WESTSIDE SUBWAY EXTENSION PROJECT

Response to Preliminary Review Comments of Century City Area Fault Investigation Report by Shannon & Wilson

Westside Subway Extension Project

April 17, 2012

Figure A-15: Plan of At-Grade Station Concept

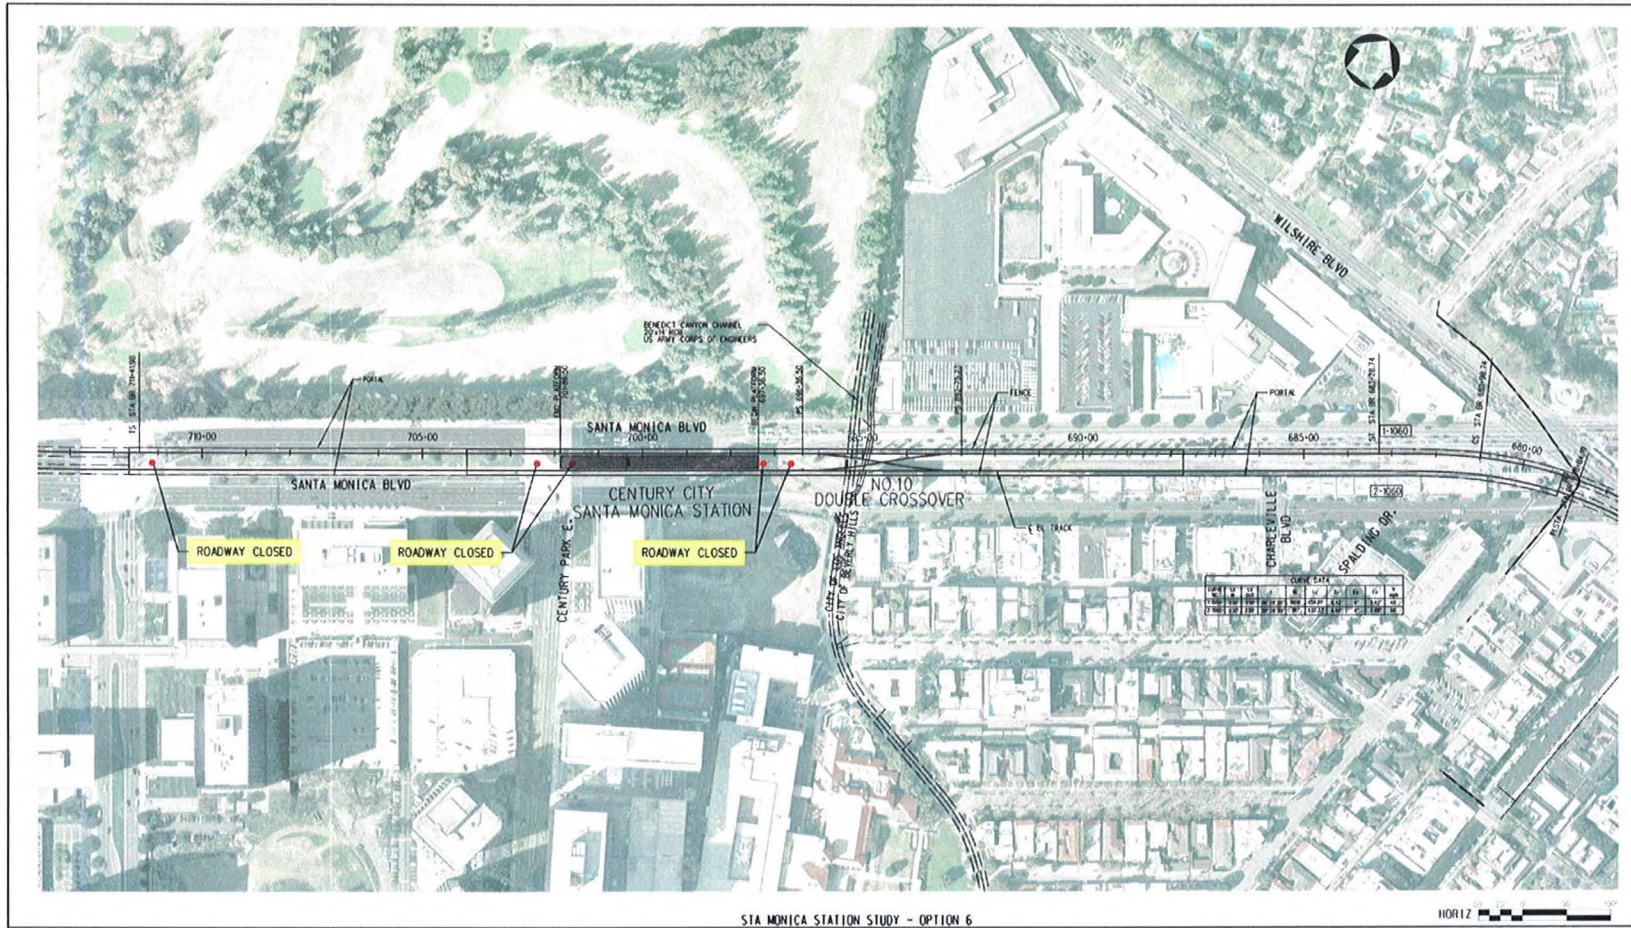
The concept for this alternative has been to use the abandoned railroad right-of-way to construct a trench so the train could transition from a subway on Wilshire Boulevard to an at-grade alignment in the center median/bus lane of Santa Monica Boulevard. To maximize the use of this former railroad right-of-way, Figure A-15 shows the east portal of the proposed at-grade section beginning at the intersection of Wilshire and Santa Monica Boulevards. The transition trench from below ground to at-grade would extend for about 900 feet and the tracks would reach the surface approximately 200 feet west of Charleville Boulevard. The train would then run in an at-grade configuration with a crossover track and at-grade station at either Century Park East or Avenue of the Stars.

Figure A-17: At Grade Platform, Typical Cross Section at Platform

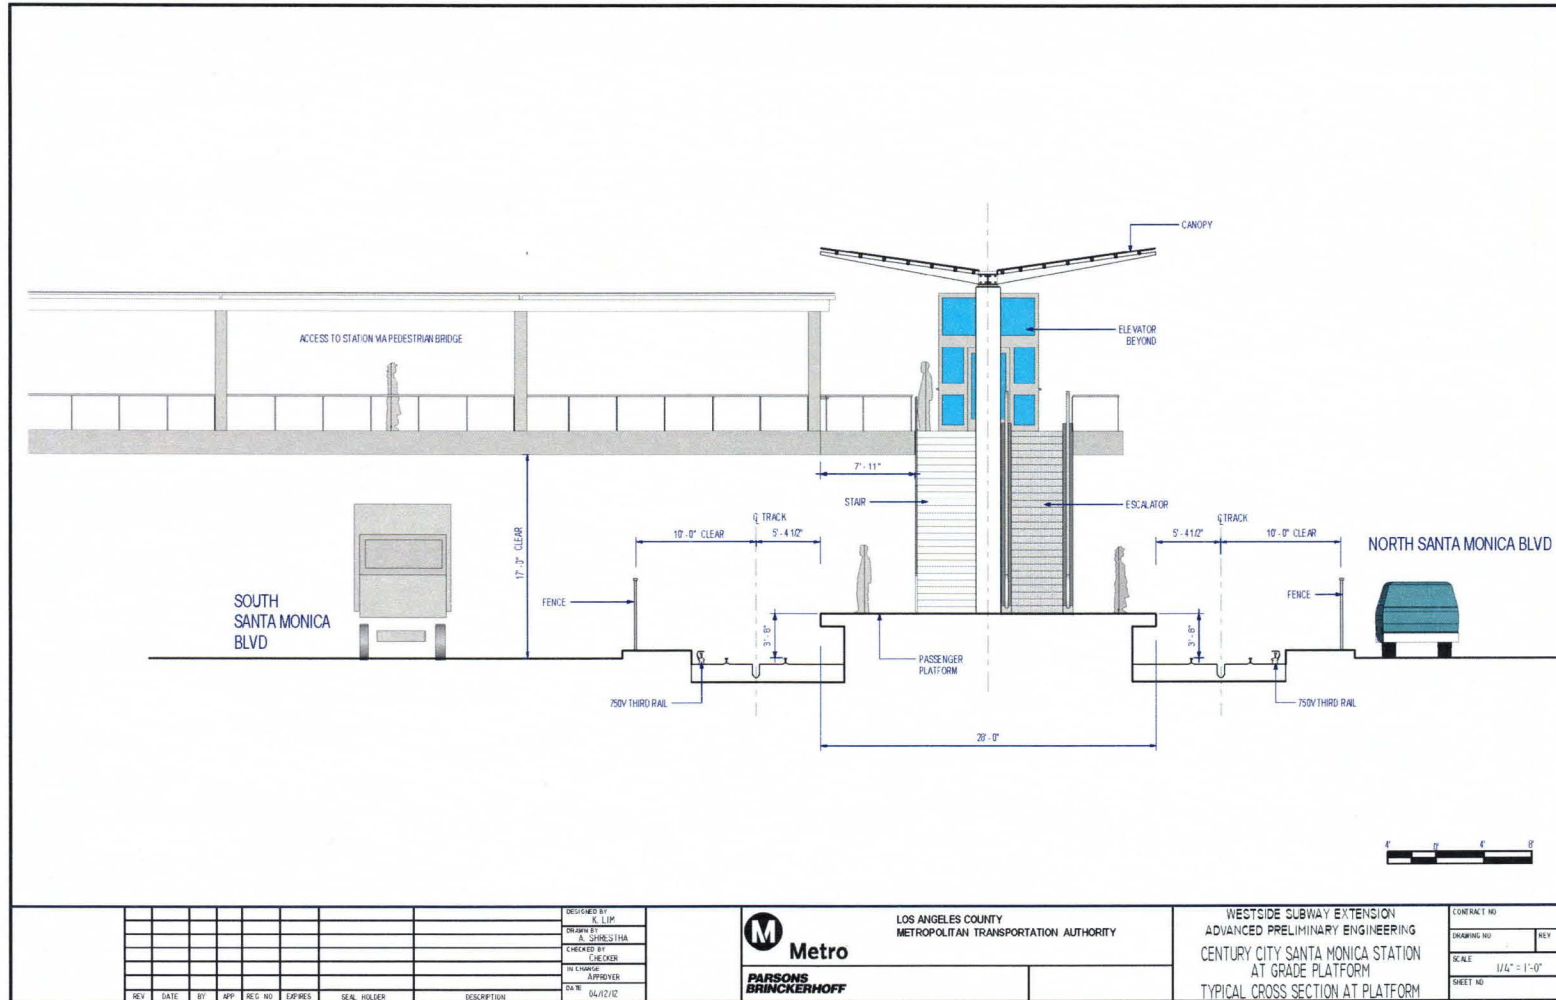
On the West side of the station, another transition trench from at-grade to below ground would be required which would extend for another 800 feet. If the at-grade station were located at Century Park East, the total length of the combination open trench and above-ground section would be over 3,200 feet in length. If the at-grade station were located between Avenue of the Stars and Century Park East, the total length of the combination open trench and above-ground section would be of similar overall length and would extend approximately 800 feet west of Avenue of the Stars. Figure A-16 shows the station located at Century Park East against the Fault Zones. Access to the station platform from Century City would need to be grade separated over the tracks and Santa Monica Boulevard (Figure A-17).

Figure A-19: Fault Zones, Aerial Station Concept

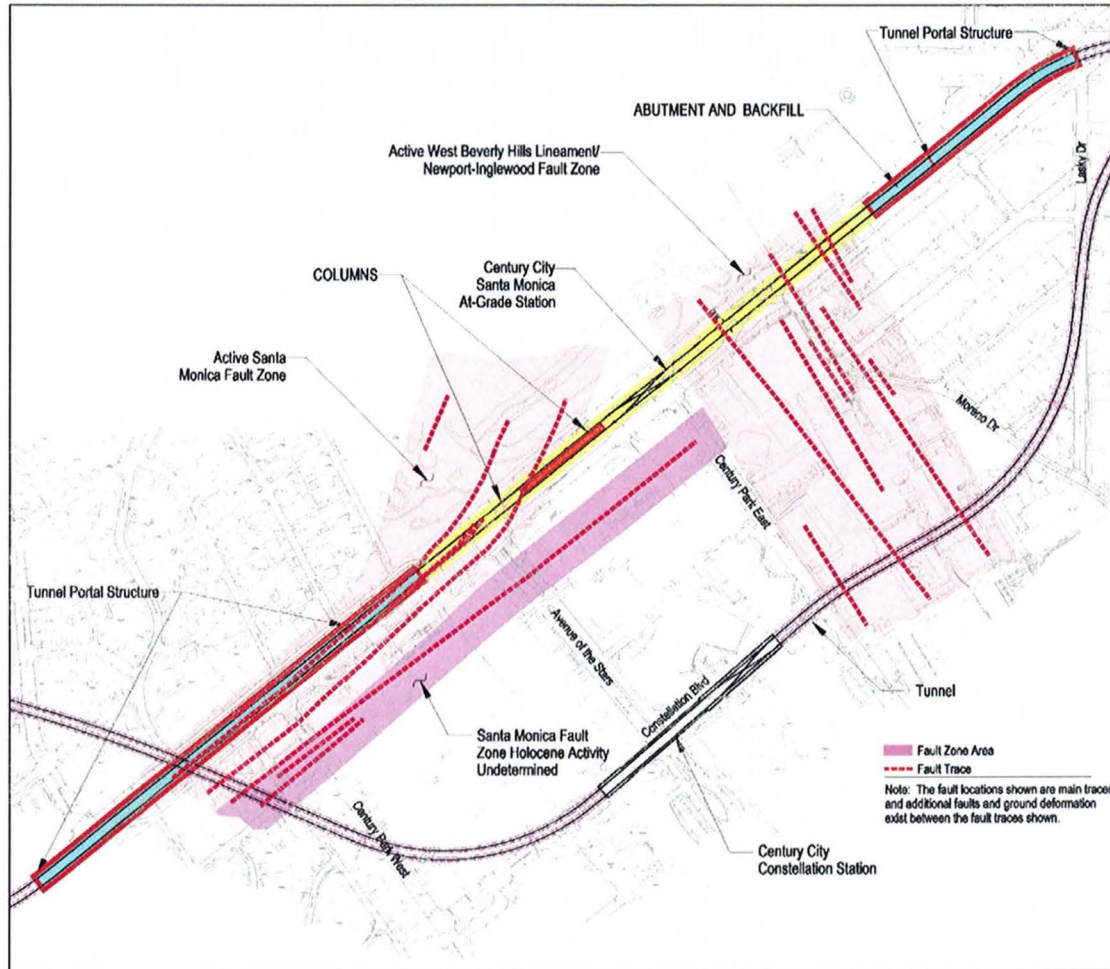
Putting the Station in an aerial configuration was suggested as an option to remove some of the traffic impacts associated with the at-grade alternative, but this would introduce other issues. The concept for this alternative shown in Figure A-18, shows the east portal of the proposed at-grade section at the intersection of Wilshire and Santa Monica Boulevard. The transition trench from below ground to aerial would extend about 800 feet west of Wilshire Boulevard. The train would then transition from at-grade to aerial on an aerial structure that would be constructed in the center median of Santa Monica Boulevard. The trains would run in an aerial configuration with a crossover track and an aerial station between Century Park East and Avenue of the Stars. On the West side of the station, the structure would descend to grade and then enter another transition trench from at-grade to below ground which would extend for another 2,100 feet. The combination open trench and above-ground section would be about 5,800 feet in length, extending from Wilshire Boulevard to beyond Beverly Glenn. Access to the station platform from Century City would need to be grade separated over the tracks and Santa Monica Boulevard as shown in Figure A-19.
